Access Compliance Report

Public Rights-of-Way

Intersection ID: 31891	Main Street: CENTERLINE_DR	Cross Street: MOUNTAIN_SPRINGS_DR	Location: SW
ADA ID: 3D597B00777B	Ramp Type: PerpDiag	Initial Pass/Fail: Fail	Overall Compliance: No
			Severity Score: 33.75

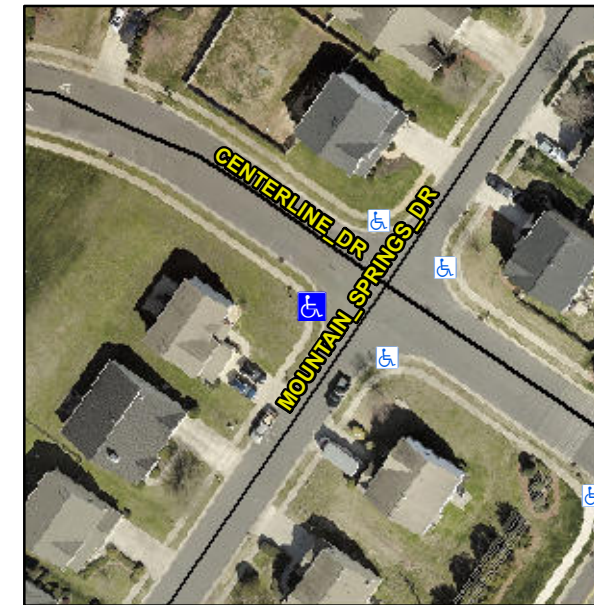
Not Found, R304.5.1, R304.5.3

Compliance	Description	Data	Compliance	Description	Data
N/A	Ramp Length (in)	46.0	Yes	Ramp Slope (%)	6.0
No	Ramp Width (in)	41.5	No	Ramp XSlope (%)	7.1
N/A	Flare Type LT	N/A	N/A	Flare Type RT	N/A
N/A	Flare Slope LT (%)	N/A	N/A	Flare Slope RT (%)	N/A
N/A	Flare Traversable LT?	N/A	N/A	Flare Traversable RT?	N/A
N/A	Landing Length (in)	N/A	N/A	DWS Provided?	N/A
N/A	Landing Width (in)	N/A	N/A	DWS Contrast?	N/A
N/A	Landing Slope (%)	N/A	N/A	DWS Length (in)	N/A
N/A	Landing X Slope (%)	N/A	N/A	DWS Full Width?	N/A
N/A	Landing Curb? (Y/N)	N/A	N/A	DWS Offset (in)	N/A
N/A	Shared Landing?	N/A			
N/A	Gutter Ponding?	N/A	N/A	Gutter Slope (%)	N/A
N/A	Gutter Lip Ht (in)	N/A	N/A	Gutter X Slope (%)	N/A
N/A	Painted X Walk1?	No	N/A	Painted X Walk2?	No
	X Walk 1 Direction	To SE		X Walk 2 Direction	To NE
N/A	X Walk 1 Width (in)	N/A	N/A	X Walk 2 Width (in)	N/A
	X Walk 1 Slope (%)	0.8		X Walk 2 Slope (%)	2.8
	X Walk 1 X Slope (%)	2.8		X Walk 2 X Slope (%)	1.9

Remove & Replace Curb Ramp With Two New Directional Ramps or Equivalent.
